Product Change Notification: P-21-020304

AMP Duoplug 2.5 Mark II Connector

Marking details for TE Collegno production

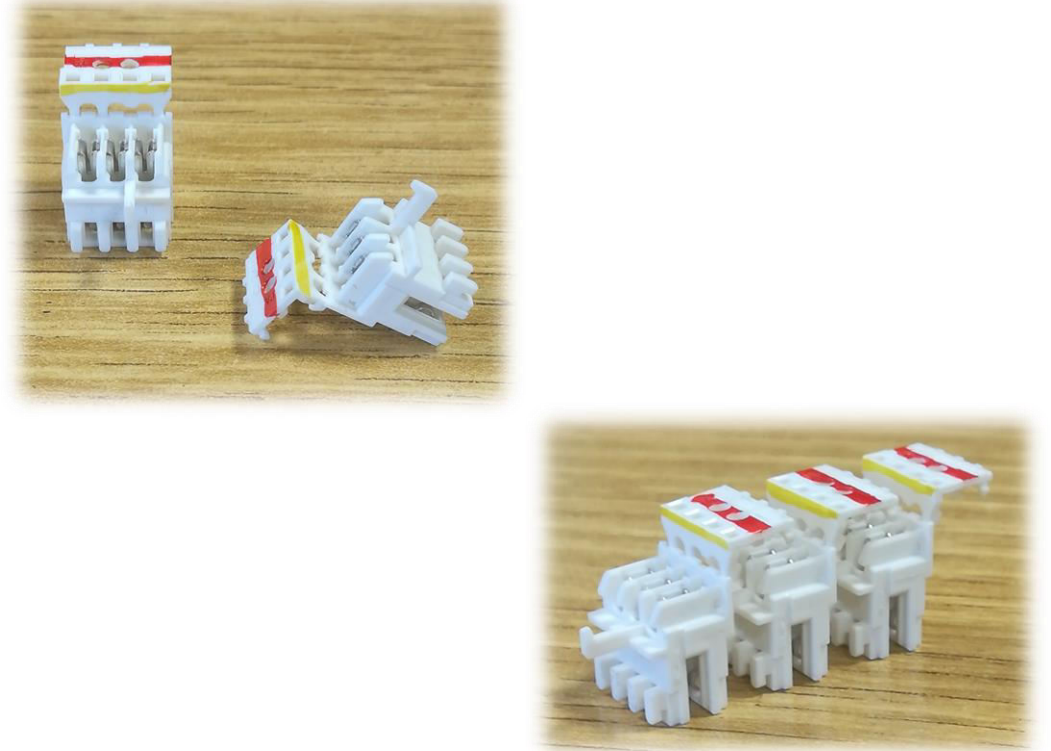
Following PCN P-20-019671, marking change from orange to a lighter color (yellow) to reduce visual impact and to differentiate from the color strip used for polarization

STRIPE in yellow color as shown, to identify the production from Collegno plant.
